Network Working Group
Request for Comments: 1151
Updates: RFC 908

Version 2 of the Reliable Data Protocol (RDP)

RDP Header Format
Figure 1

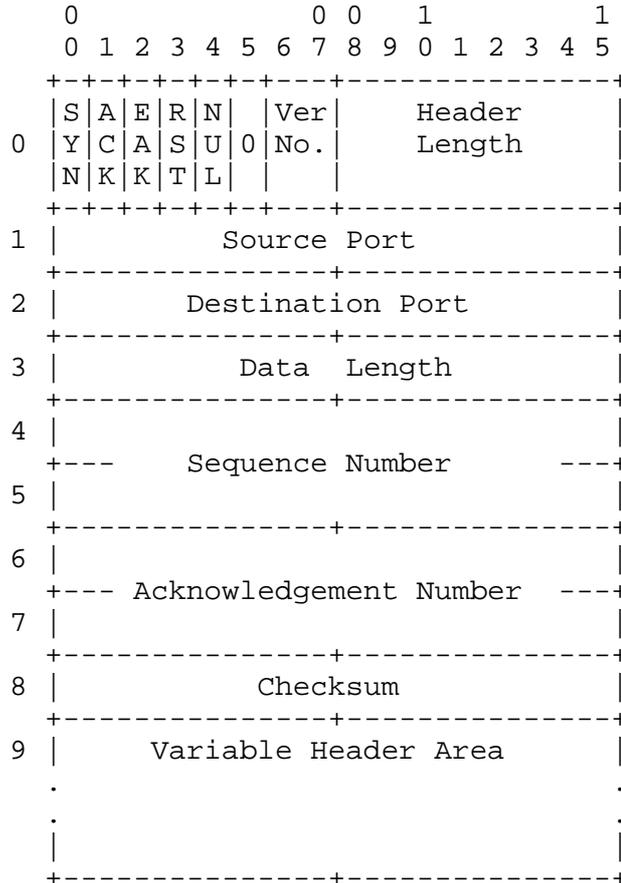
There are three changes to the protocol header: the checksum algorithm has been changed, the port size increased, and the version number incremented. The new header format is shown in Figure 1.

The major discovery during the testing of the protocol is that cost of computing the the RDP checksum proved surprisingly variable; its performance was more heavily affected by the host's data representation than anticipated. Optimized checksum implementations on two comparable hardware bases gave performance that differed by a factor of five. Since the speed of the checksum is a key factor in the performance of the protocol itself, this variation caused a noticeable difference in throughput.

The 8-bit port size is probably too small to support a large range of applications. Accordingly, the port size is now 16-bits. Port numbers less than 1024 are reserved for well-defined applications. Allocable ports begin at port number 1024.

Finally, because the checksum and port size have been changed, the version number has been increased to 2.

The wide variation in performance on comparable machines was felt to be undesirable, so the checksum has been changed. RDP now uses the 16-bit TCP checksum, which is specified on page 16 of RFC-793.
